REZONING APPLICATION

8/12/19 Plan Commission Meeting

Village Planner Report

PLANNED DEVELOPMENT DISTRICT (PDD) REZONING, CERTIFIED SURVEY MAP (CSM) & SITE PLAN APPLICATIONS

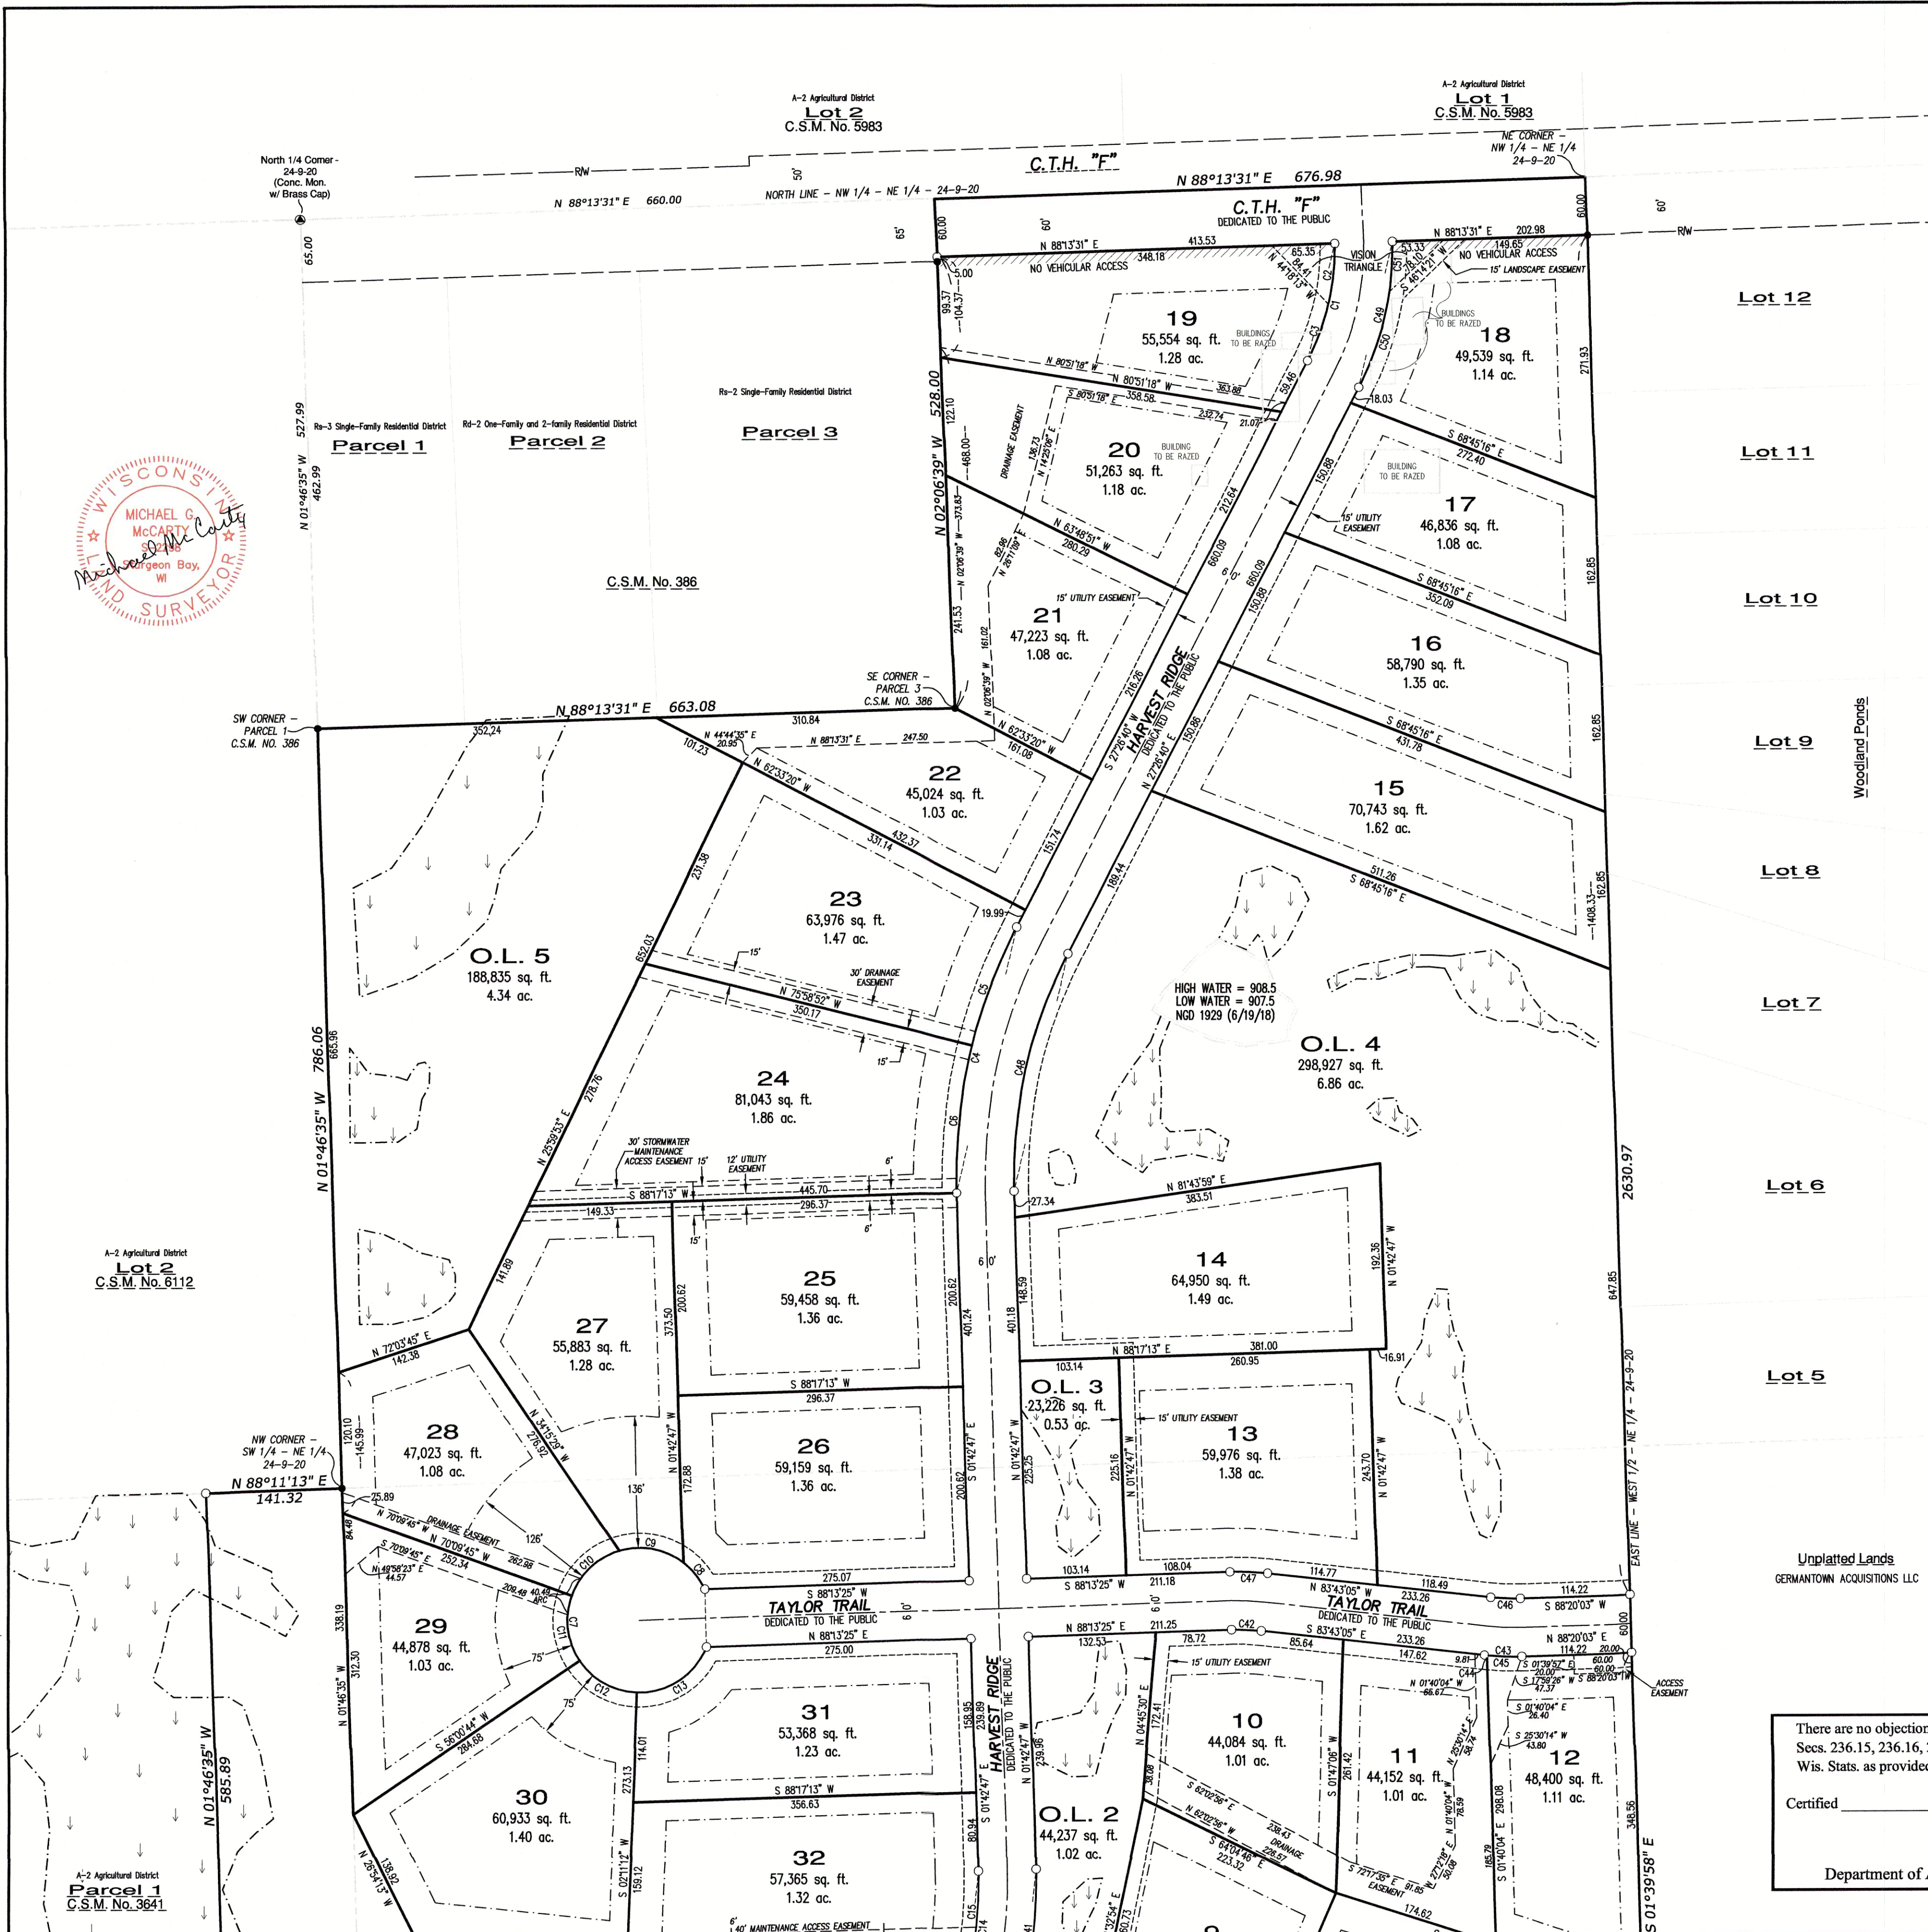
On Sheet 1, the bearing of the east exterior boundary of the plat must be shown.

-When you replot your drawing, please add the O.L. 4 and O.L.5 labels on Sheet 2.
